Letter of Intent

The purpose for this application is to request administrative relief from the corner lot setback for lot 24 of parcel number 5507206036 (Springs at Waterview – Filing No. 1). The subdivision is almost entirely comprised of 50' wide lots that feature 5' side lot setbacks. As such, the community was designed for plans that are up to 40' of buildable width. As such, it is clear that the intended buildable width for this

$\underbrace{\textit{VICINITY} \;\; \textit{MAP}}_{\text{N.T.S.}}$

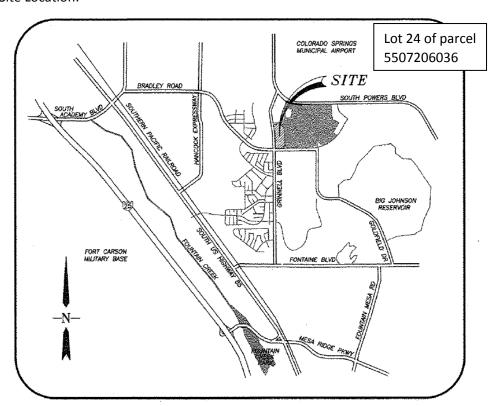
parcel ID should be 5507206061
